DART SERVICE INSTRUCTION

TO AMEND INSTALLATION INSTRUCTIONS D350-591 REV. E

REF. CANADIAN STC SH92-6

HIGH GEAR STEP

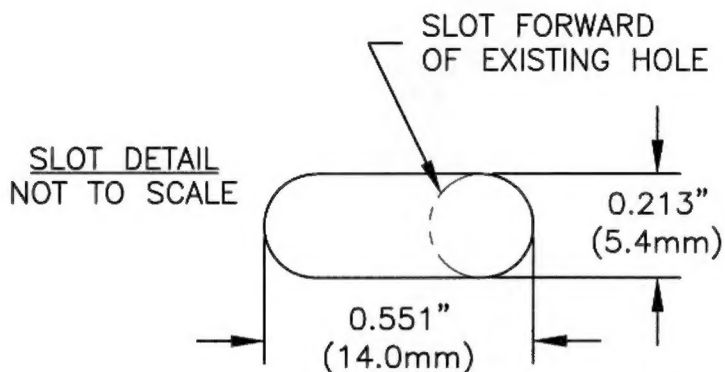
TO ALLOW FOR BETTER FIT ON SOME LANDING GEARS, IT IS ACCEPTABLE TO SLOT FRONT ATTACHMENT HOLES OF THE DART D350-591-211/-212 STEPS 0.551"x0.213" (14.0mm x 5.4 mm) AS SHOWN BELOW. TOUCH-UP PAINT FINISH PER ICA-D350-591 Rev. Ø AS REQUIRED.

DESIGN UP	DRAWN BY UP	DART AEROSPACE LTD HAWKESBURY, ONTARIO, CANADA	
CHECKED [Signature]	APPROVED [Signature]	DRAWING NO. DSI 9249	REV. B SHEET 1 OF 1
DATE 03.02.27		TITLE STEP ATTACHMENT HOLES	SCALE NTS
A	03.02.13	NEW ISSUE	
B	03.02.27	0.551" (14.0mm) WAS 0.410" (10.4mm)
